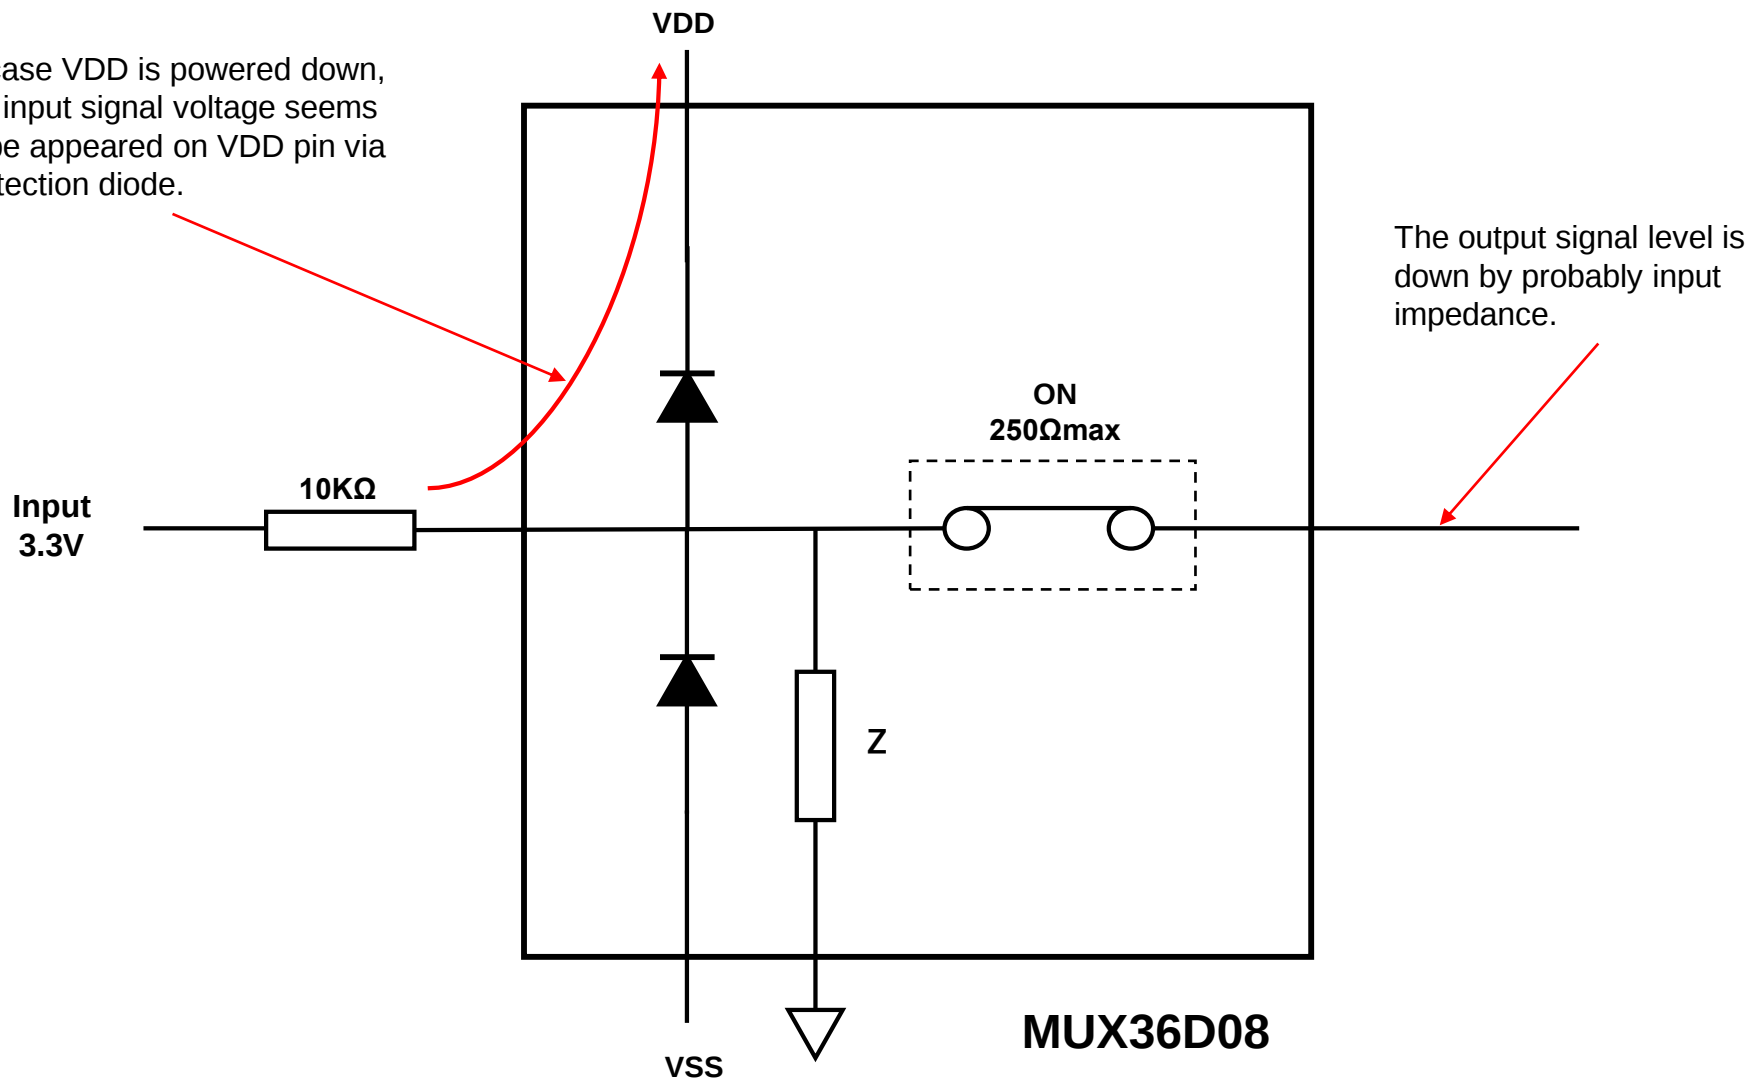
In case VDD is powered down, the input signal voltage seems to be appeared on VDD pin via protection diode.

The output signal level is down by probably input impedance.

Question ①

Is it possible to place diode between VDD and VDD pin to protect ?

But in case placing additional diode, the protection diode will not work??
